6220 ROOSEVELT

REVIEW OF EDG & ADJUSTMENTS

COMMENTS FROM EDG REPORT 7/10/24

MASSING ADJUSTMENTS

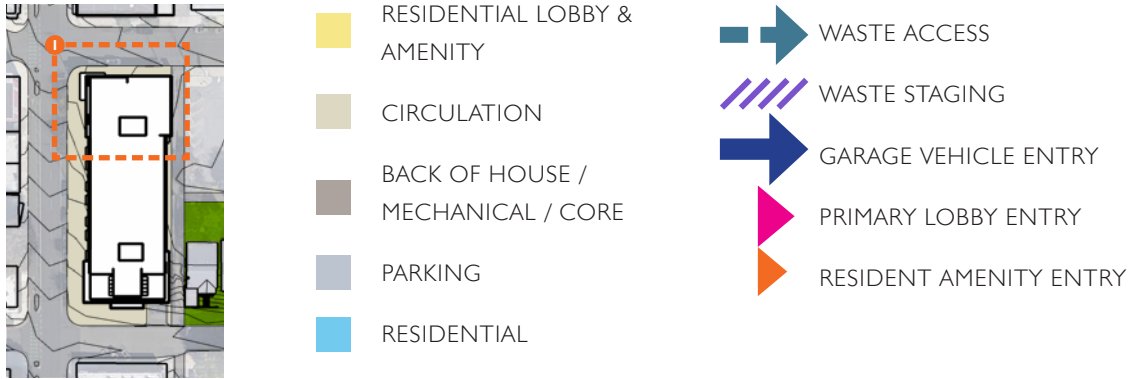
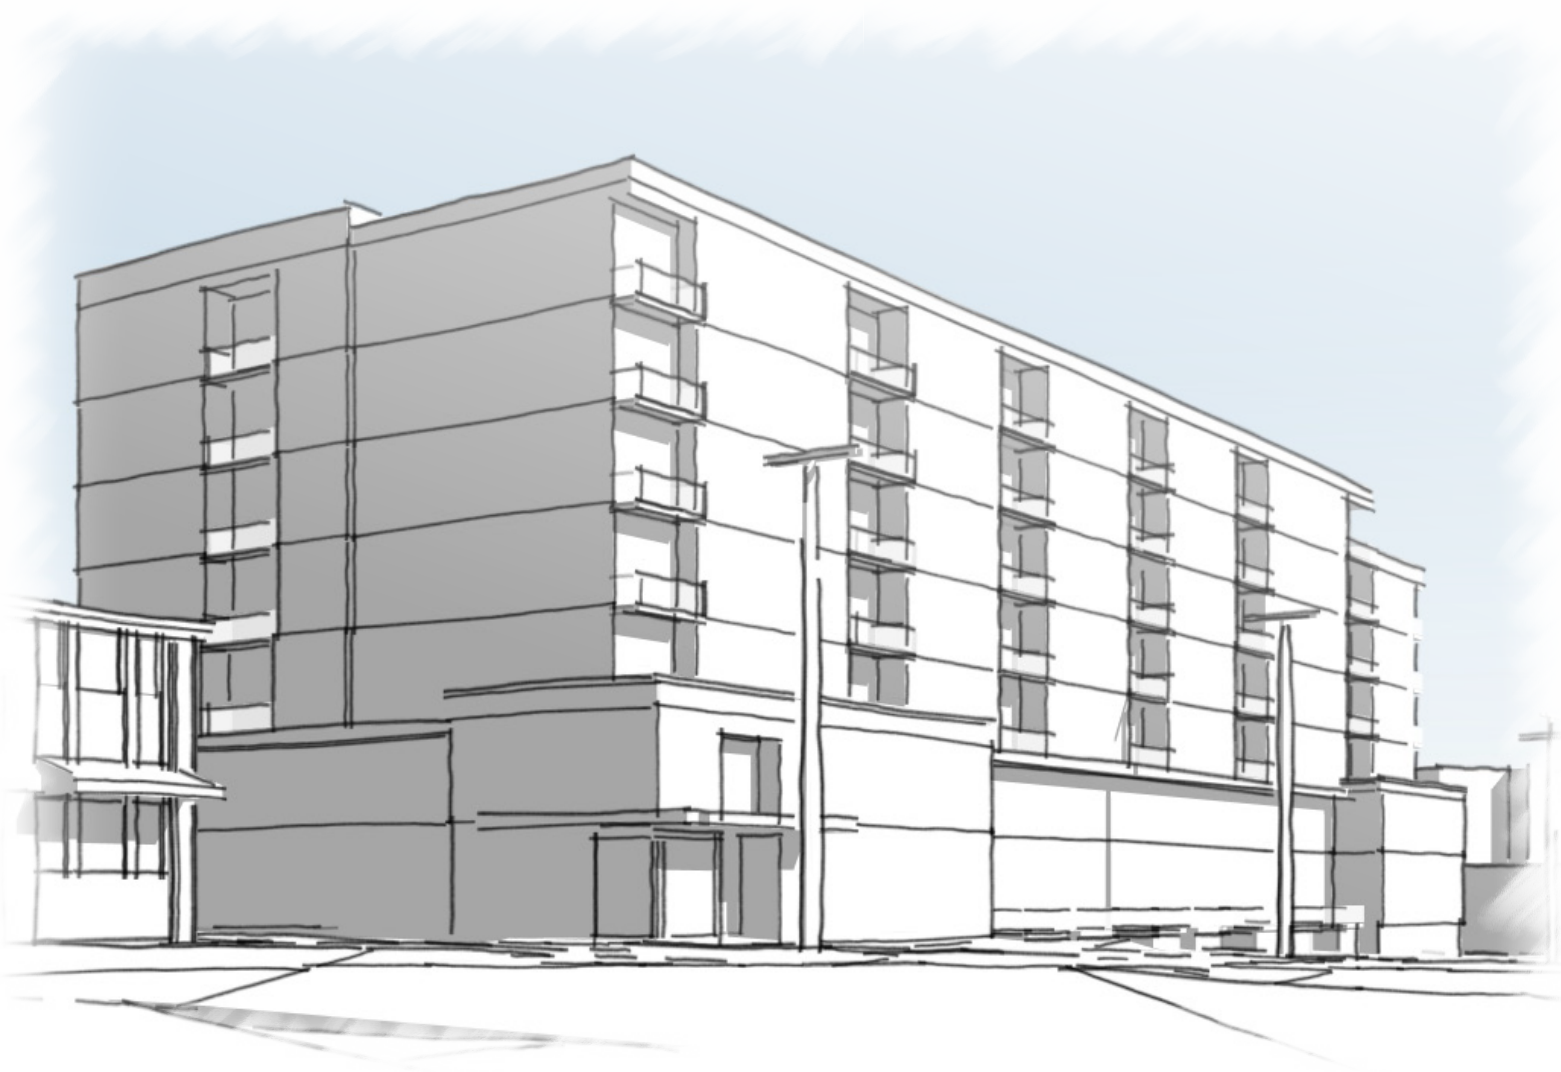
EDG Report Comment 1b:

The board strongly supported the recessed balconies on option 3 and asked these elements be retained. They requested the balconies be deep enough for use. They also specifically noted how the corner balconies reduce the appearance of scale.

The darker graphic overlay indicates where the recessed balconies noted by the board have been maintained.

The revised massing maintains the recessed balconies noted by the board.

For consistency and consideration of the neighboring property, the corner balconies were relocated to the center of the southern massing. Here the exterior space does not look directly down on the neighbor.

REVISED ENTRY MASSING

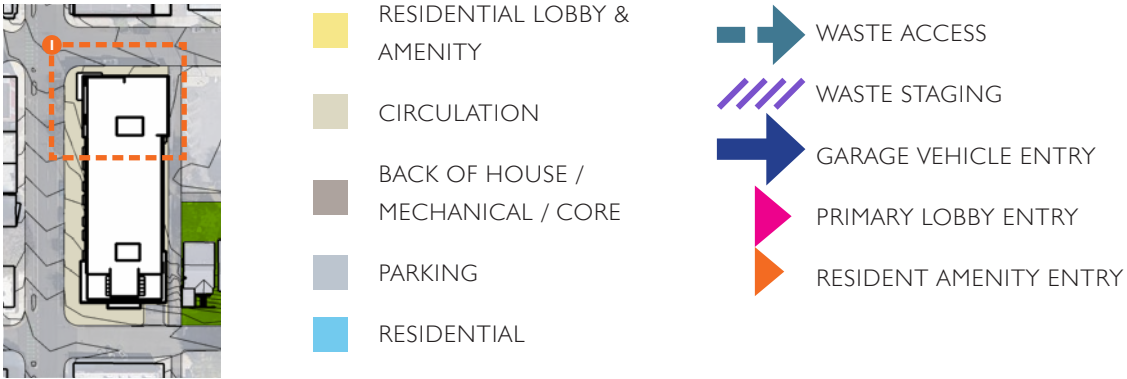
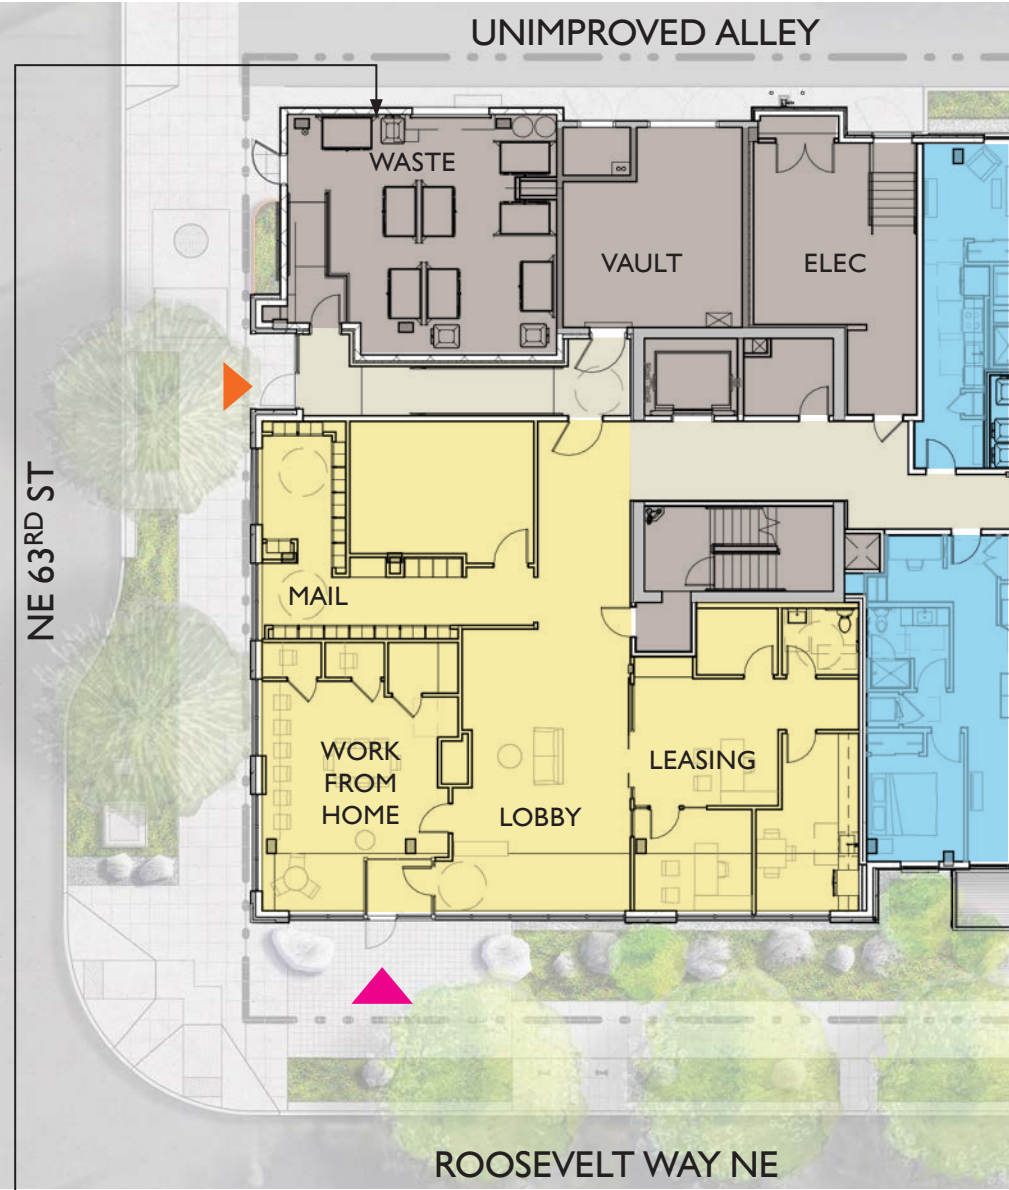
EDG Report Comment 1c:

The board wanted to see more transparency and prominence at the residential lobby to better engage the street.
(See pages 8-11 for more information)

EDG Report Comment 2d:

The board wanted to ensure the necessary utility frontages are nicely incorporated into the street facades.
(See pages 8-11 for more information)

DCI.B.1 / DCI.C.4: Although the alley will remain unimproved after much negotiation with SPU, waste pick up will occur just inside the alley, removing the waste room roll up door from the street facing facade and allowing for a more pedestrian friendly streetscape.

CS2.B.2: An additional secondary entry at the eastern end of the lobby provides better access for residents and more engagement with the street.

CS2.B.2: The revised, extended massing places more lobby glazing directly adjacent to the 63rd Street sidewalk. The revised massing also downplays the utilitarian frontage.

The entry design provides more glazing both directly at the entry itself, as well as in other areas of the lobby. The glazing is also less interrupted by pilasters for more continuous transparency.

EDG: SOUTHERN ACTIVATION & USES

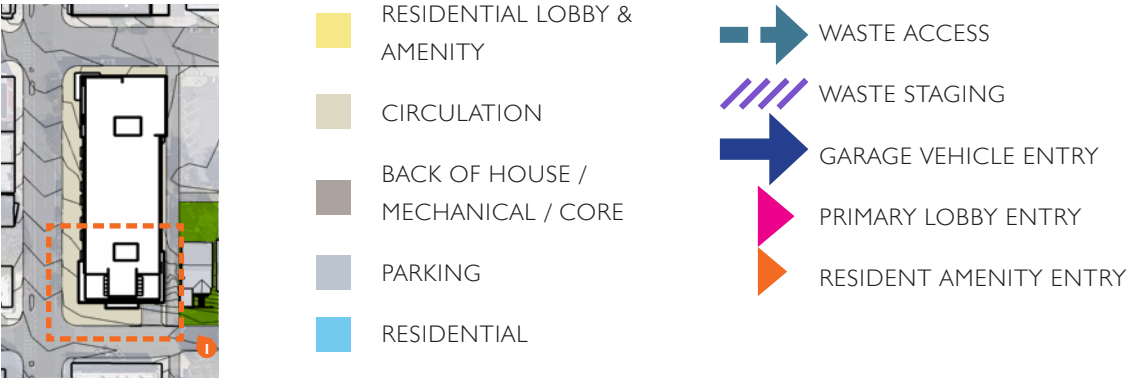
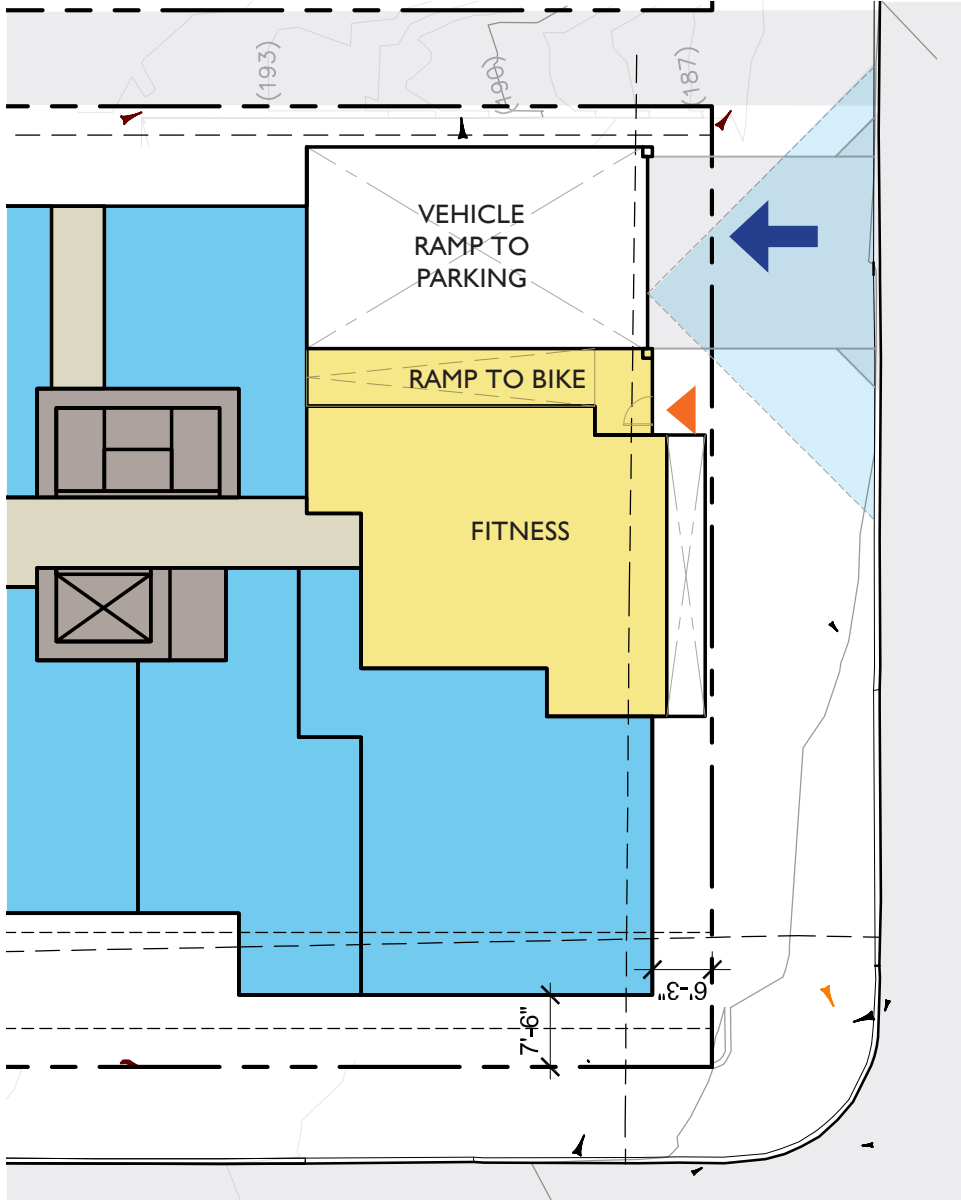
EDG Report Comment 2b:

The board wanted to ensure the building animates and engages Roosevelt and 63rd.
(See pages 8-11 for more information)

EDG Report Comment 2c:

The board was concerned about the proximity of the bike room and pedestrian entrance to the garage vehicle entry.
(See pages 8-11 for more information)

REVISED SOUTHERN ACTIVATION & USES

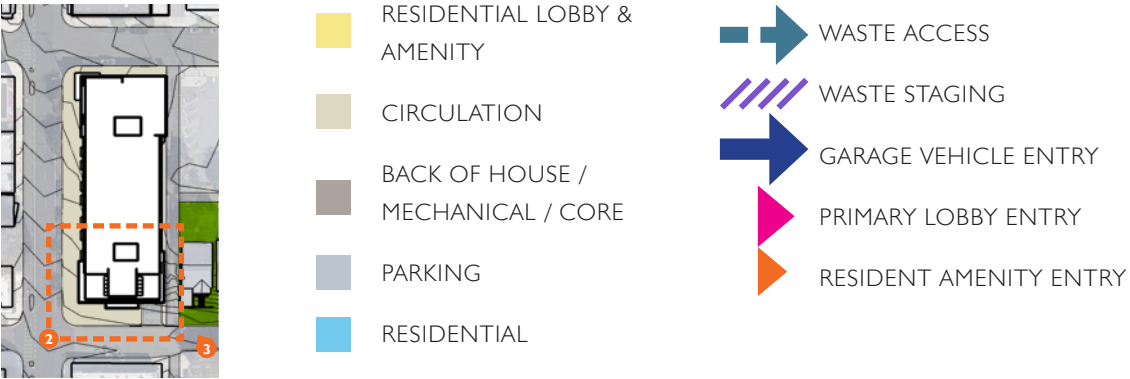
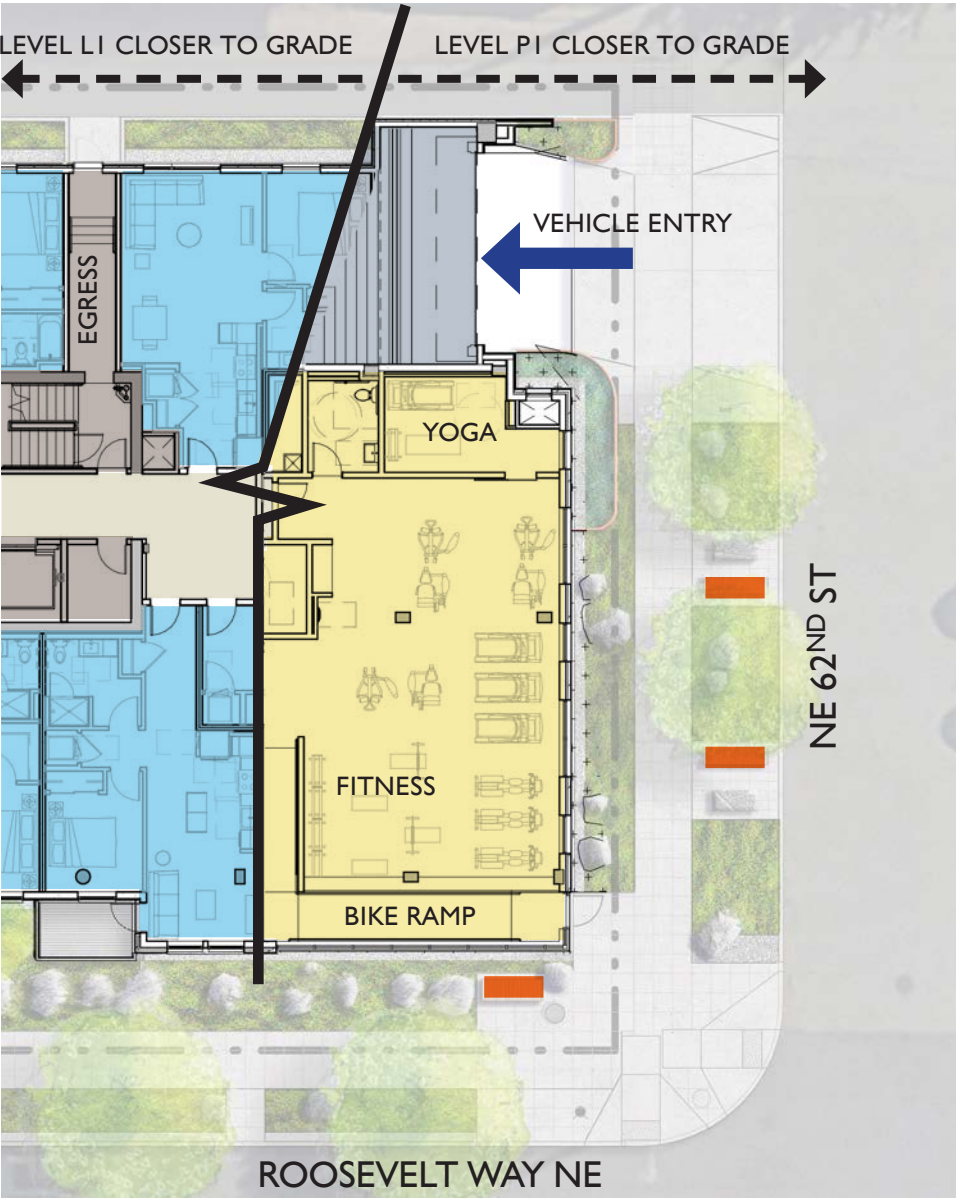
EDG Report Comment 2b:

The board wanted to ensure the building animates and engages Roosevelt and 63rd.
(See pages 8-11 for more information)

EDG Report Comment 2c:

The board was concerned about the proximity of the bike room and pedestrian entrance to the garage vehicle entry.
(See pages 8-11 for more information)

The revised design better engages both Roosevelt and 62nd by relocating the amenity entry here. Double height glazing, a canopy, and internal art installation add interest to the streetscape and connect interior activities to the streetscape.

PL2.I.v: The amenity and bike entry has been relocated to the corner of Roosevelt and 62nd eliminating conflict between cars and pedestrians or cyclists.

Glazing directly into the fitness amenity provides a visual connection between interior and exterior. Although the interior floor height is lower than adjacent grade, the windows extend over 5 feet above grade putting them well within pedestrians sight lines for connection.

APPROACH ON ROOSEVELT

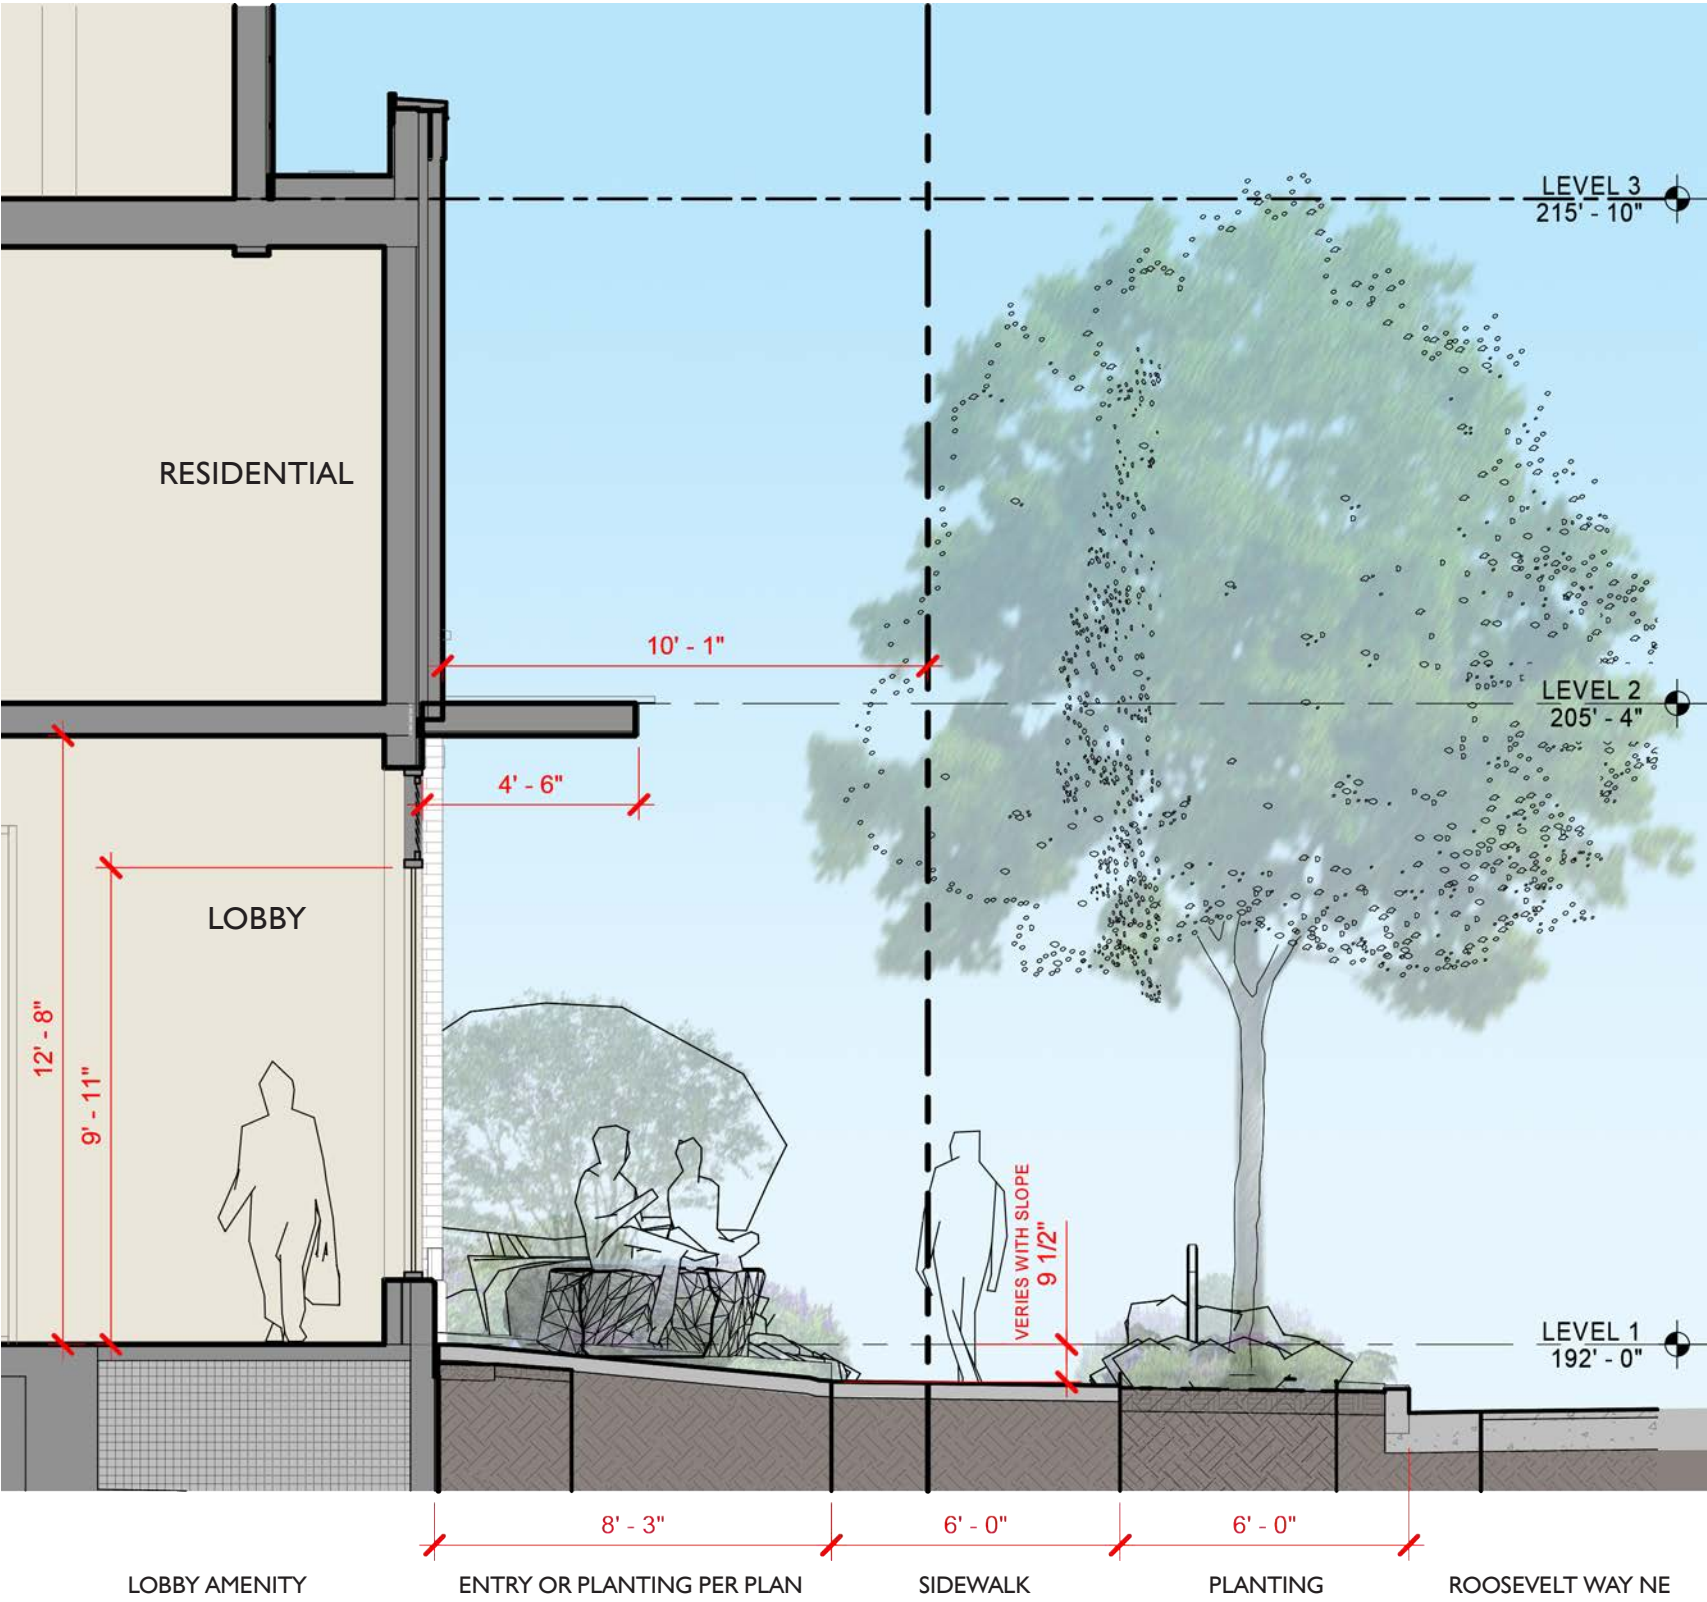
EDG Report Comment 1c:

The board wanted to see more transparency and prominence at the residential lobby to better engage the street.
(See pages 8-11 for more information)

PL2.C: A large canopy provides coverage at the main lobby entry. It provides weather protection over the entry call box and adjacent seating as well.

PL2.D / PL3.A: Significant glazing, bench seating, and the flow of the sidewalk leading to the front door provide natural wayfinding to the main lobby entry. Signage and the canopy further emphasize the entry.

DC4.II.i: Building identification and entry signage wrap the brick corner at Roosevelt and 63rd. The low placement of this signage is easily identifiable for pedestrians.
